## RESIDENTIAL DEVELOPMENT ASSESSMENT SHEET

APPLICATION DETAILS			
FILE NO: PA23/303			
OFFICER NAME	David Quelch		
PROPOSAL	Dwelling		
LOCATION	Lot 118, 9 McNeil Grove, Jarrahdale		
APPLICANT	Rural Building Company Pty Ltd		
OWNER	Erin and Paul Gill		
APPLICATION RECEIVED	24 April 2023	APPLICATION DATED	19 April 2023
ZONING	Residential (R12.5)	LOT AREA	850m <sup>2</sup>

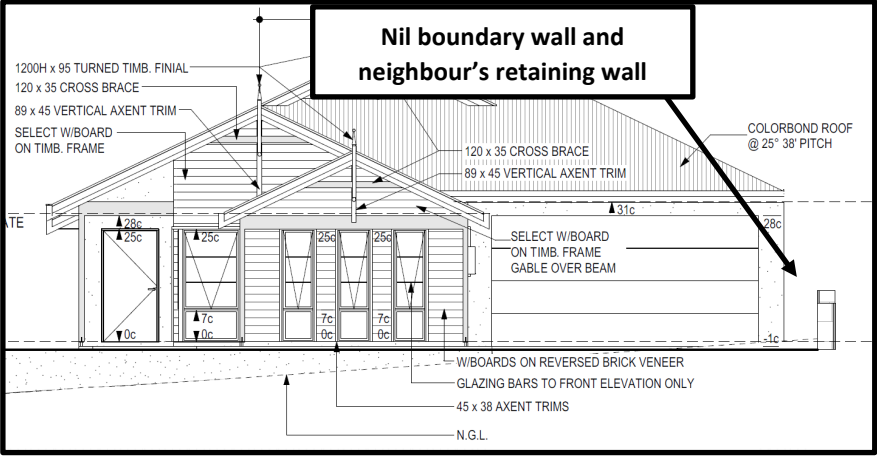
<b>Clause 5.1.3 Lot Boundary Setback</b>	
<b>Design Principles</b>	<b>Comments</b>
P3.1 Buildings set back from lot boundaries so as to: <ul style="list-style-type: none"> <li>• Reduce impacts of building bulk on adjoining properties.</li> </ul>	Rear boundary setback variation Regarding the variation to the 6m rear (north) setback requirement, this is considered reasonable given the irregular shape and reduced depth of the subject site. This combined with a narrow lot frontage has resulted in the dwelling being pushed closer to the rear boundary than would normally occur on a regular shaped lot. Officers identify that the 3.38m building setback from the rear boundary is taken from the nearest corner of the dwelling. Only a small proportion of the dwelling would be within the 6m rear boundary setback.  Nil boundary wall variation The finished floor level of the proposed boundary wall is between 0.8m - 1.1m below the neighbors retaining wall and ground level (pictured in the below image).

Clause 5.1.3 Lot Boundary Setback	
Design Principles	Comments
	 <p>Therefore, the proposed nil boundary wall of 2.657m would effectively appear as a 1.8m high wall. Officers consider that as a result, the overall height and bulk of the dwelling is reduced when viewed from the east adjoining property, resulting in minimal visual impact.</p>
<ul style="list-style-type: none"> <li>Provide adequate direct sun and ventilation to the building and open spaces on the site and adjoining properties.</li> </ul>	<p>Rear boundary setback variation</p> <p>The dwelling would not result in overshadowing to the north rear boundary and is set back sufficiently to ensure ventilation flows to that boundary.</p> <p>Nil boundary wall variation.</p> <p>The proposed nil boundary wall is a garage and laundry. These rooms do not have any windows and are non-habitable rooms, so not require direct sun or ventilation.</p> <p>Regarding the impact to the adjoining property, as stated earlier the nil lot boundary wall is set lower than the adjoining property. Therefore, there would be a minimal impact to overshadowing to that property. Officer assessment concludes that no more than 0.8% of the neighbouring site will be shaded by the proposed dwelling, at the point of assessing overshadowing per the R Codes. This is compliant with the 25% deemed-to-comply standard of the R-Codes.</p>
